HARTZELL PROPELLER INC.
SERVICE BULLETIN

HC-SB-61-269

Propeller - Hub Inspection

This page transmits Revision 2 to Service Bulletin HC-SB-61-269.

Figure 1

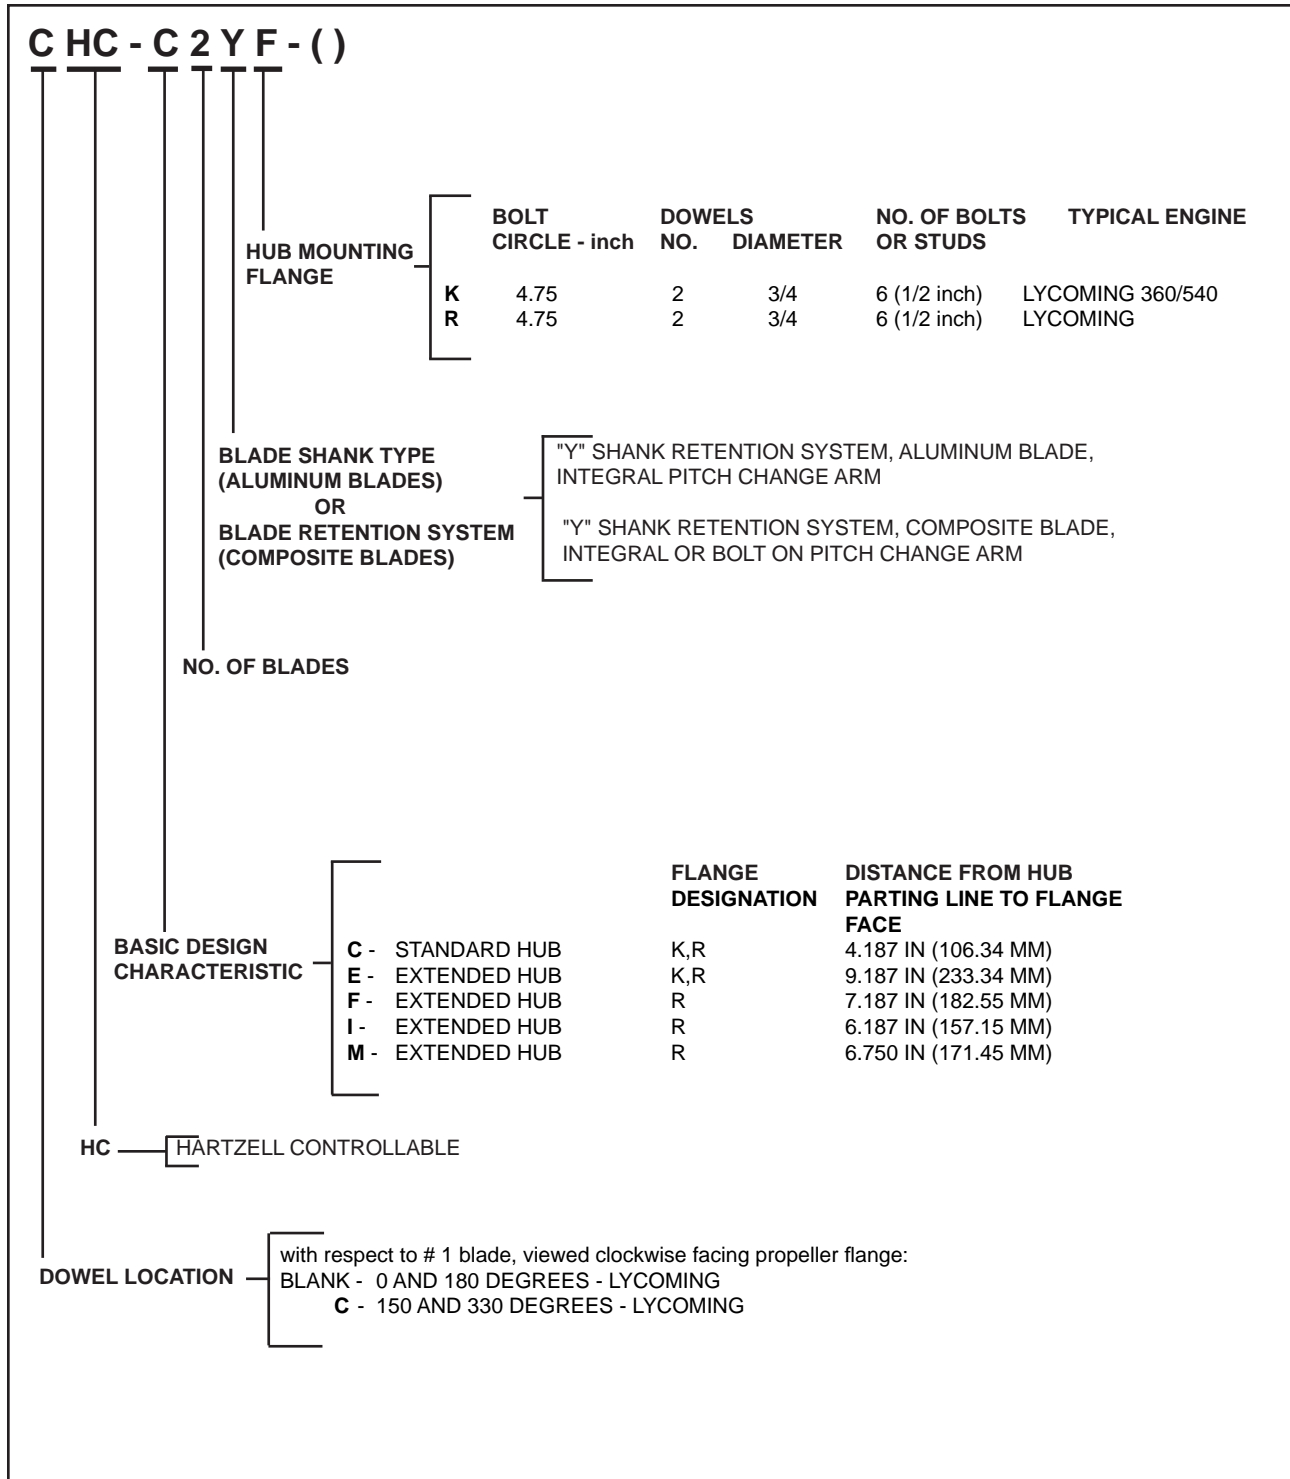
NOTE 1: The parenthesis shown in the model designations throughout this Service Bulletin indicate letter(s) and/or number(s) that may or may not be present because of different configurations permitted on the various aircraft installations. Definition of propeller model designations and further details of letters that may be present are shown in Figure 1.
